# PERMIT 346173

## SEWAGE DISPOSAL SYSTEM

HOWARD COUNTY HEALTH DEPARTMENT

SUBDIVISION Laurand LOT 3 ROAD 17630 Hardy Road

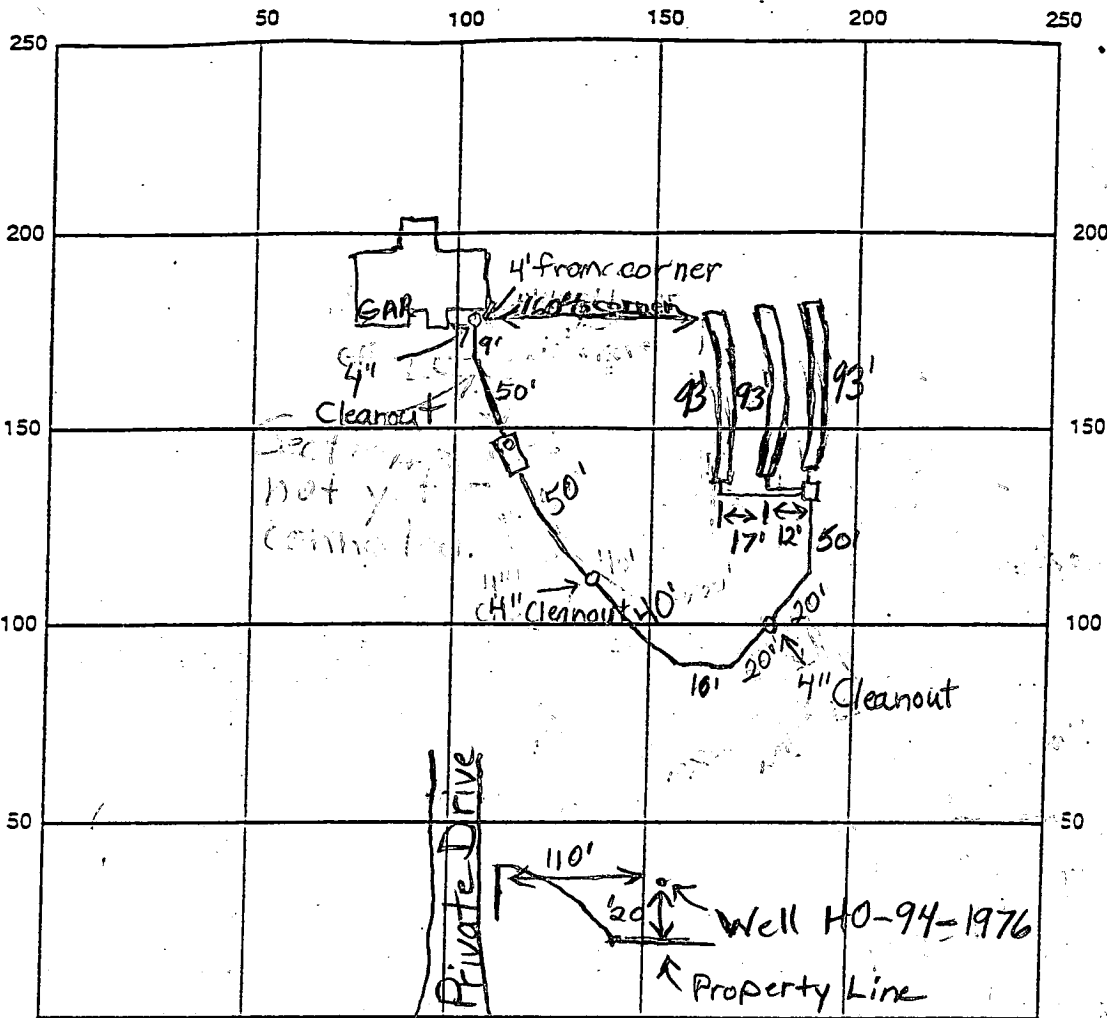
REMARKS: 7/2/99 - Area from septic tank to house unfinished. The area from the house to the first 4" cleanout is too low and needs to be regraded. Septic tank is 18" above grade. Contractor said he will put stone around pipes and move more dirt to the area. O.K. to cover everything up to tank. WPI inspection O.K. (BB) Septic line from house to tank 2' depth. Tank 1' depth. House connection made. O.K. to cover.

LOT 3  
 LAURAND  
 (HARDY ROAD)  
 ELECTION DISTRICT NR 4  
 HOWARD COUNTY, MARYLAND  
 SCALE: 1"=60' FEB. 1999

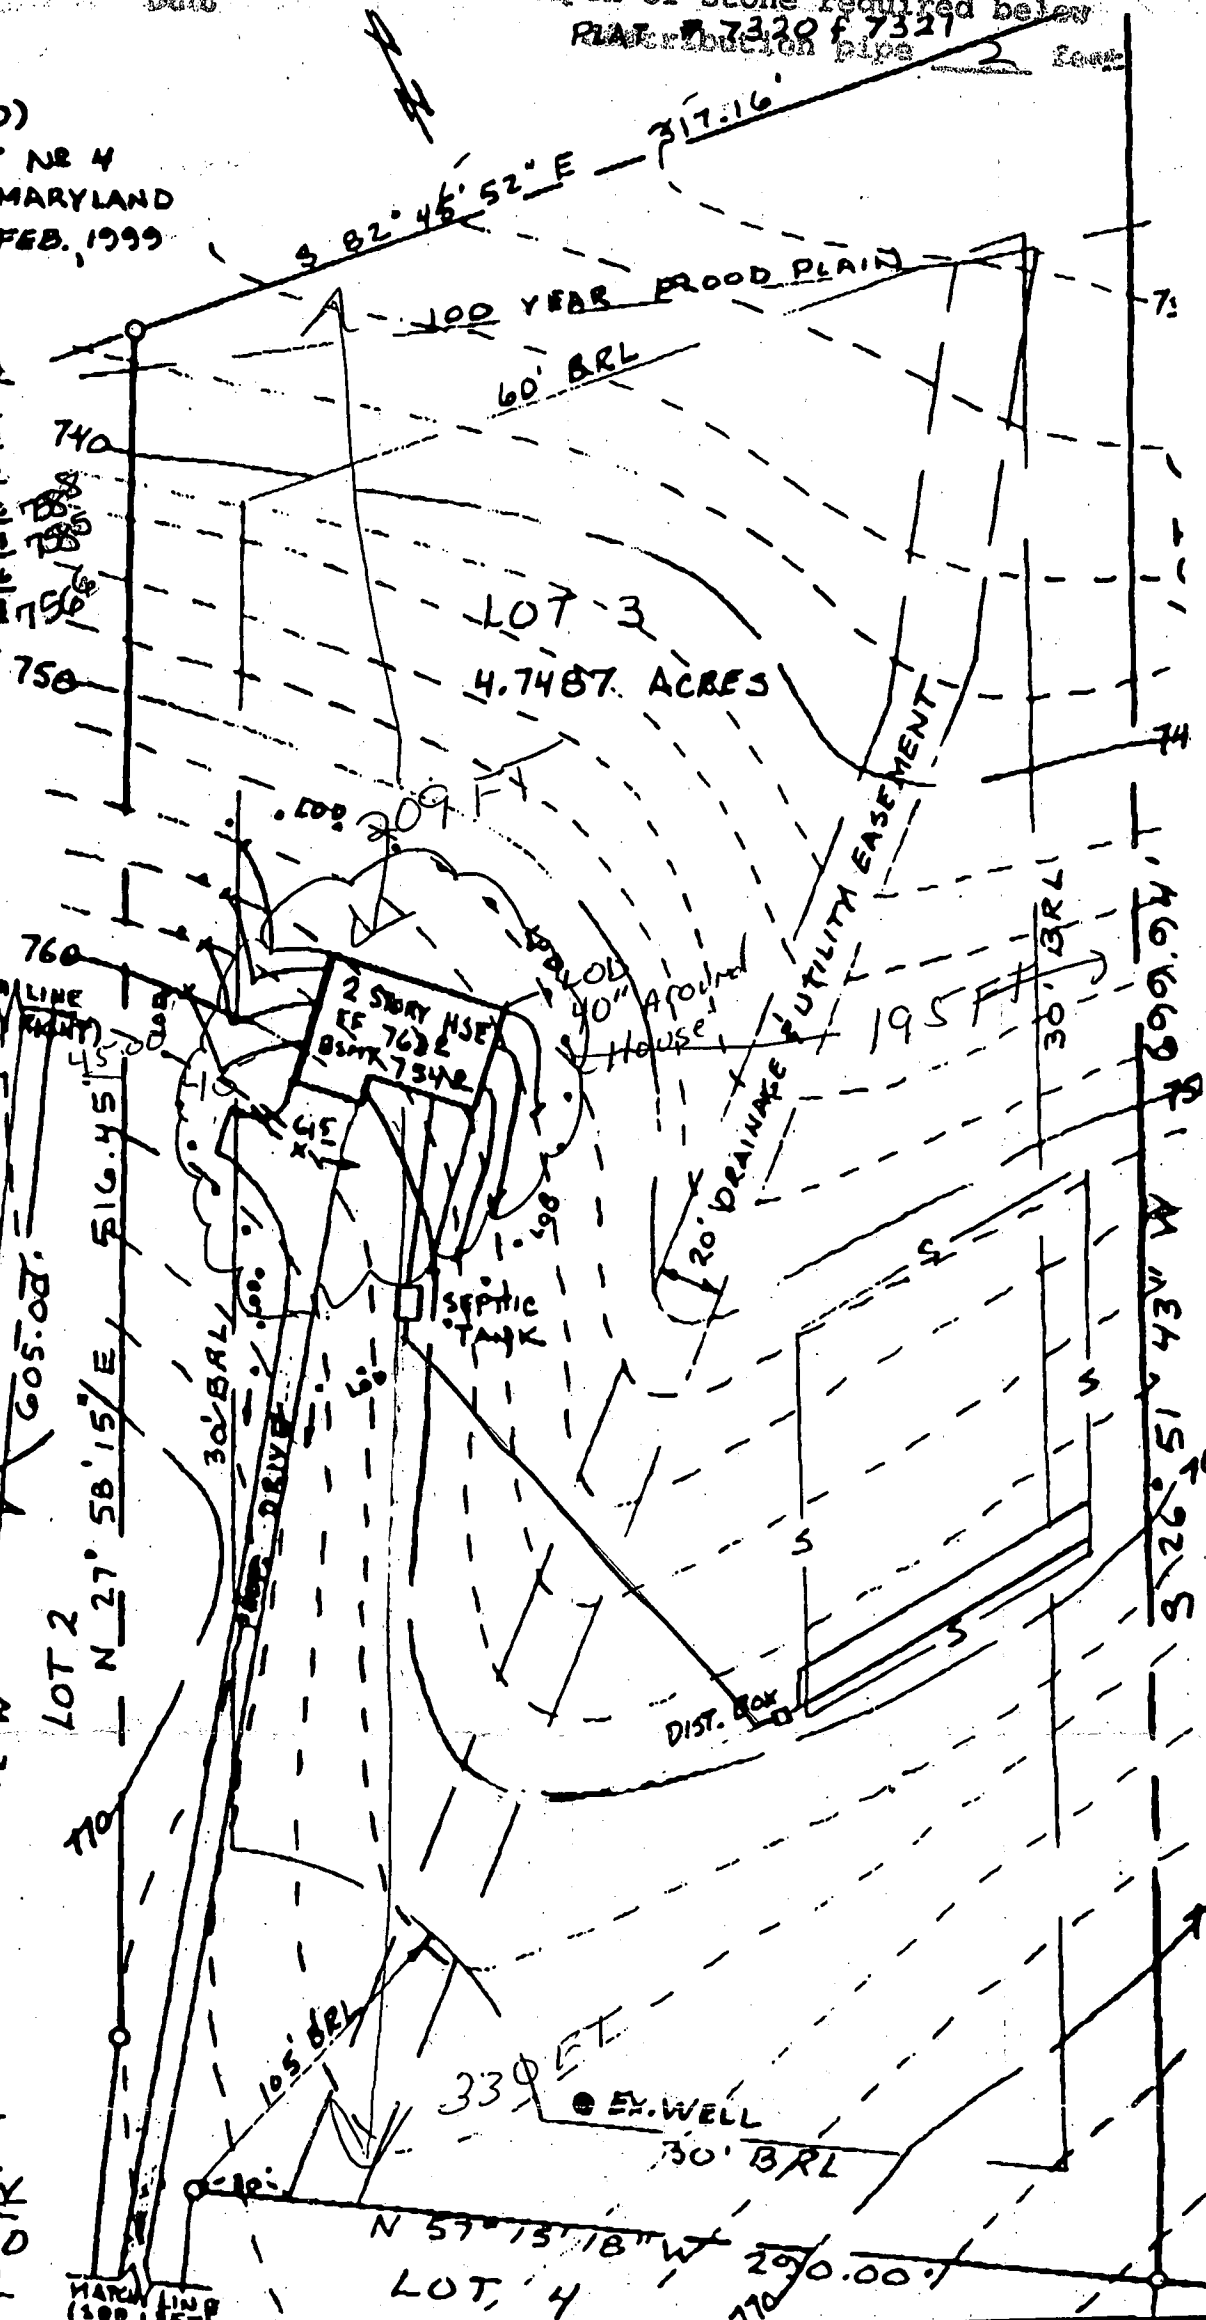
House shifted slightly  
but should not affect  
MATCHLINE
